Potential Amendments to the Sept. 14, 2012 Draft ERC Regulating Plan

Staff and Planning Commission recommended changes to the Sept. 14 draft E. Riverside Corridor Regulating Plan:

Figure 1-5: East Riverside Corridor Collector Street Map

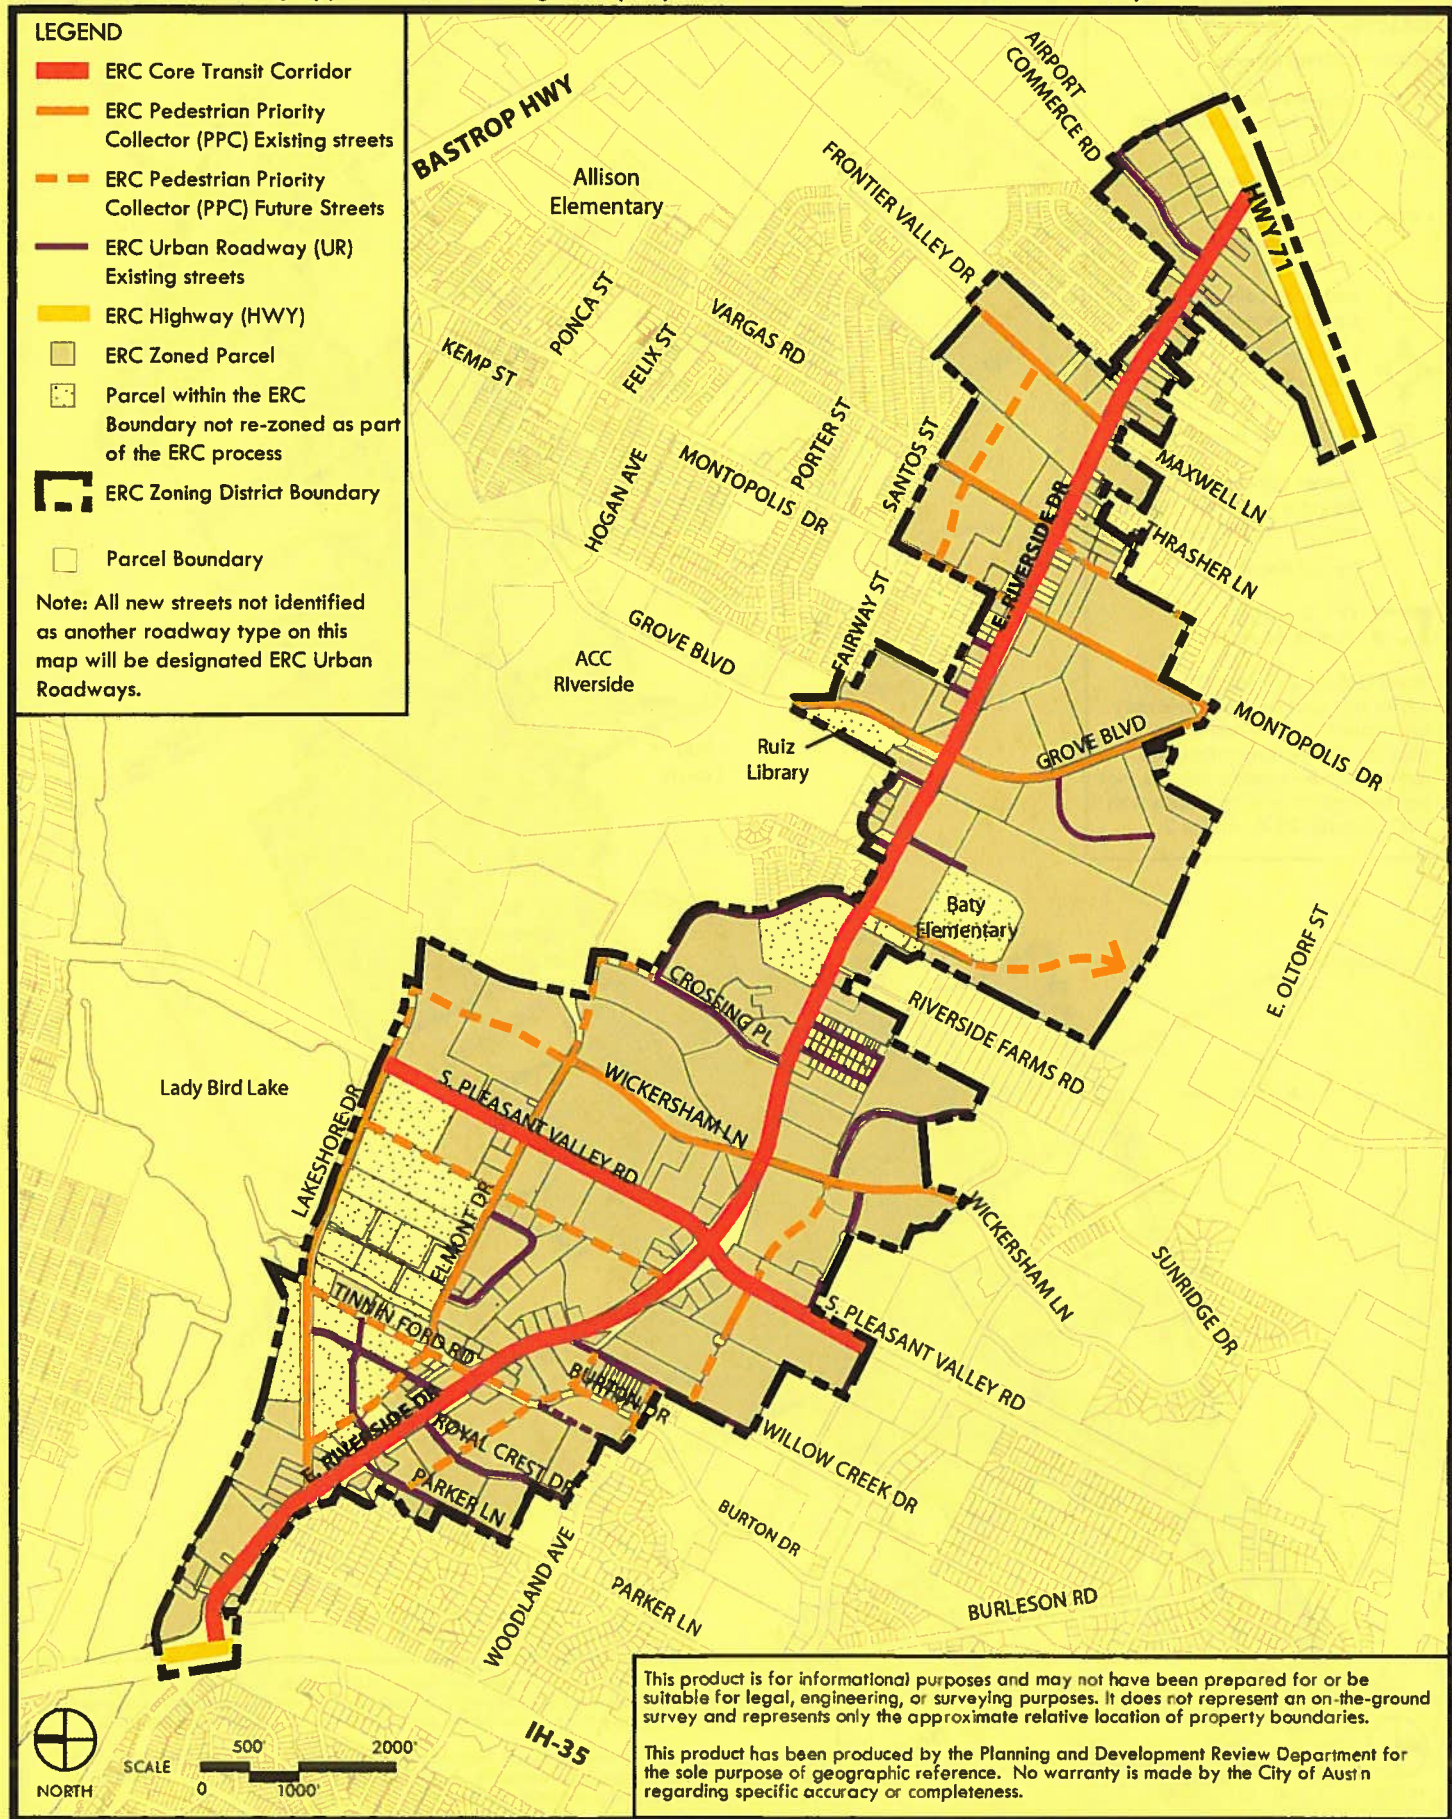
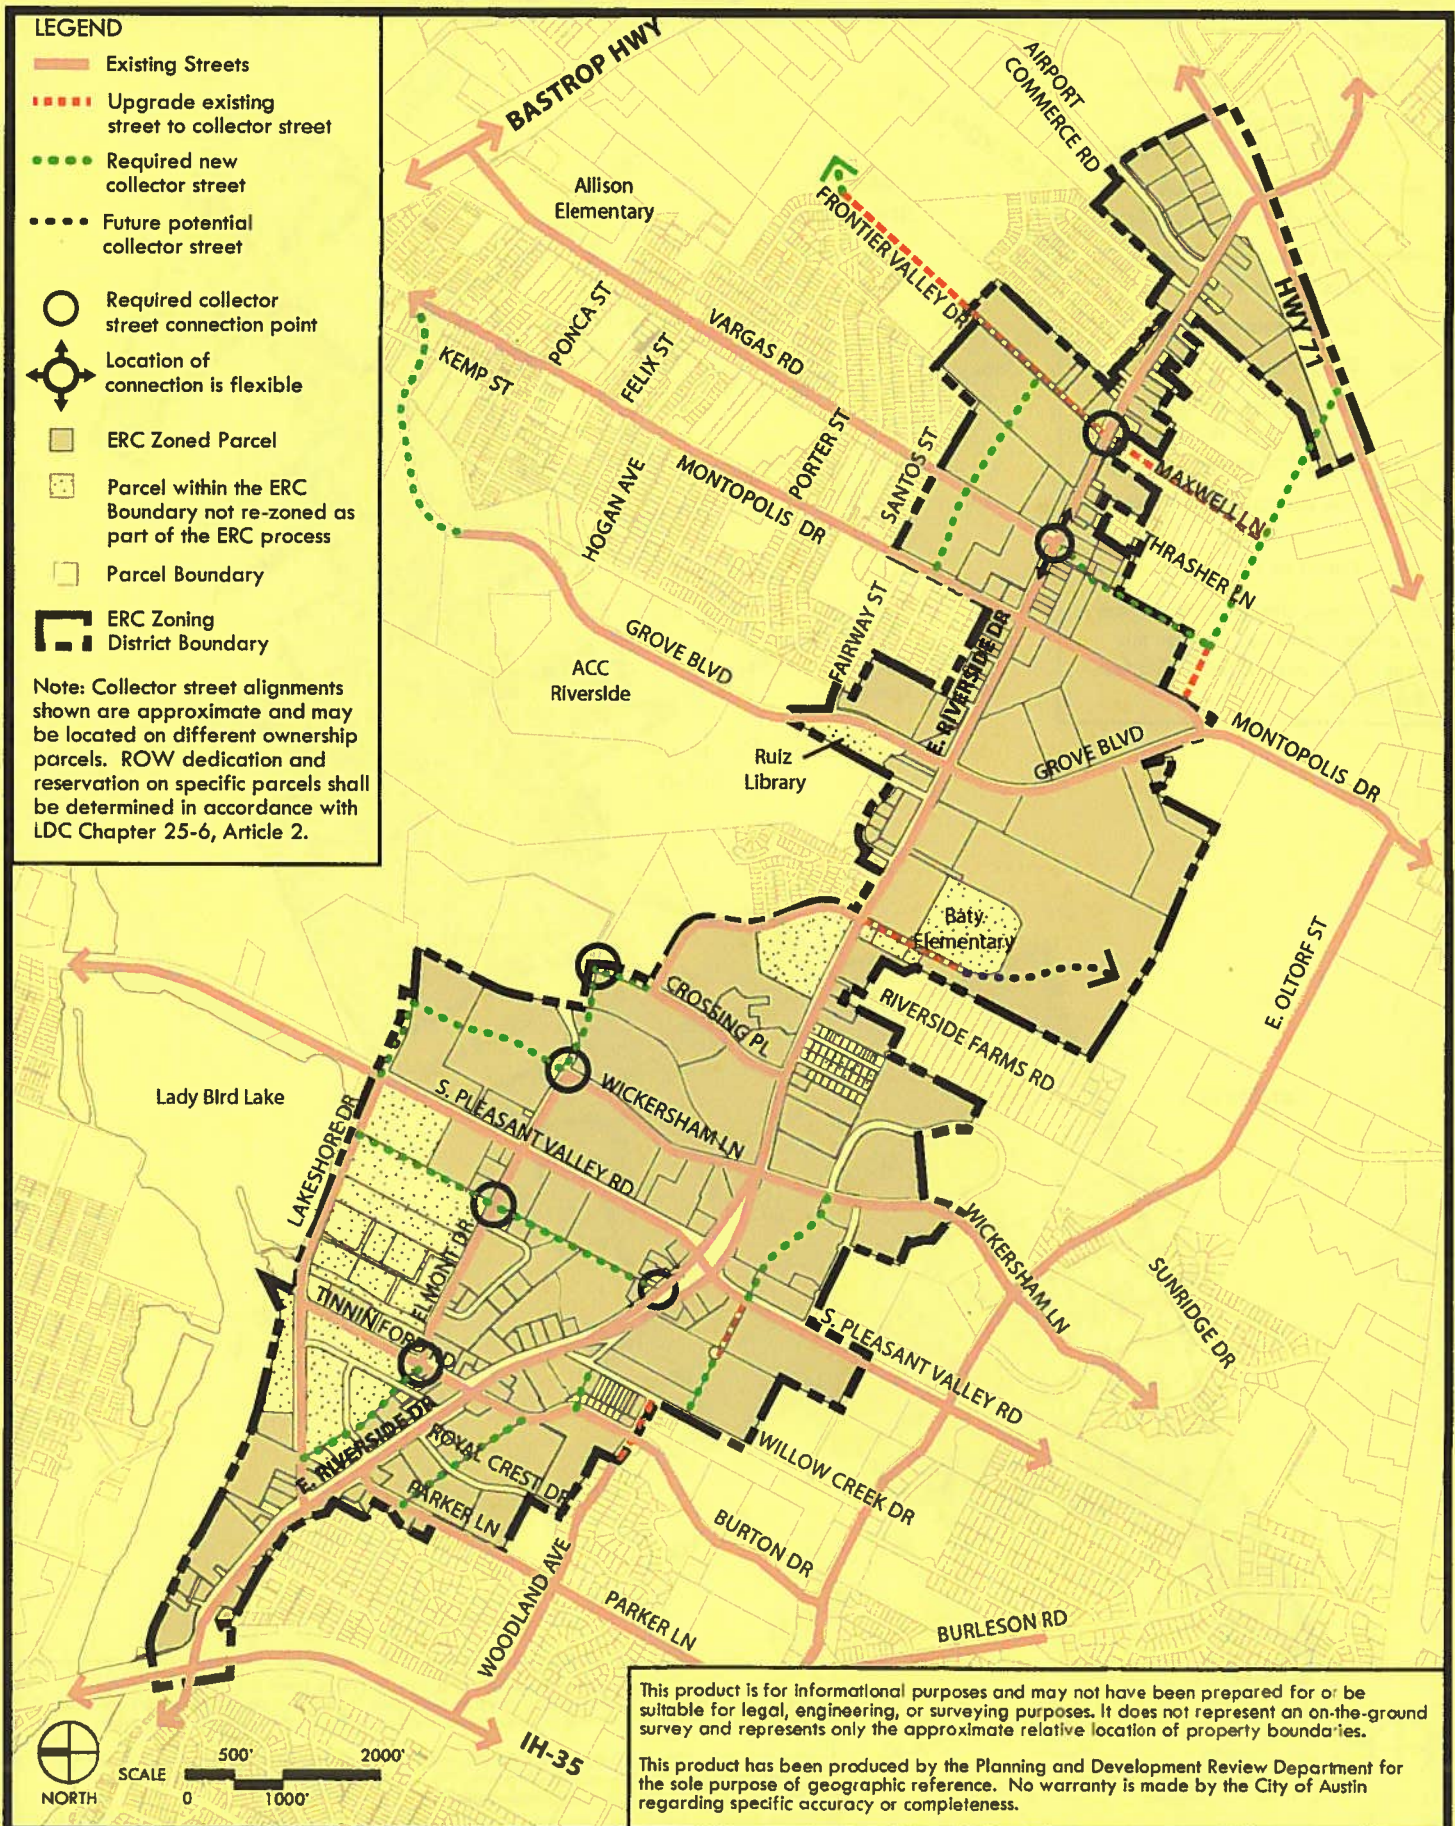
18. P. 15, Modification to collector street map to account for an existing drainage way. See revised Figure 1-5: East Riverside Corridor Collector Street Map (Nov. 8, 2012 DRAFT – see attached) and associated Figure 1-3: East Riverside Corridor Roadway Type Map (Nov. 8, 2012 DRAFT– see attached).

The map below indicates the properties within the ERC planning boundary with the Specific Regulating District (SRD) FLUM designation.

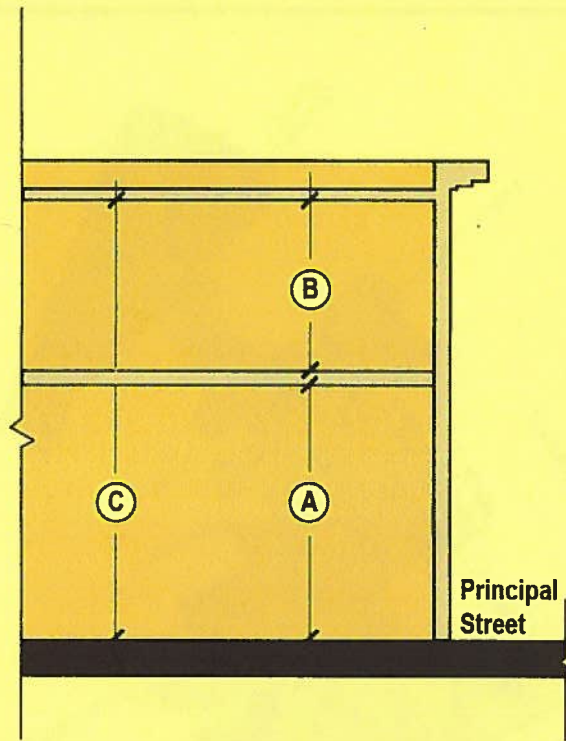
14. P. 24. Add new Figure 1-14: East Riverside Corridor (ERC) Future Land Use Map (Nov. 8, 2012 DRAFT – see attached) (**Note:** Added for clarification purposes.)
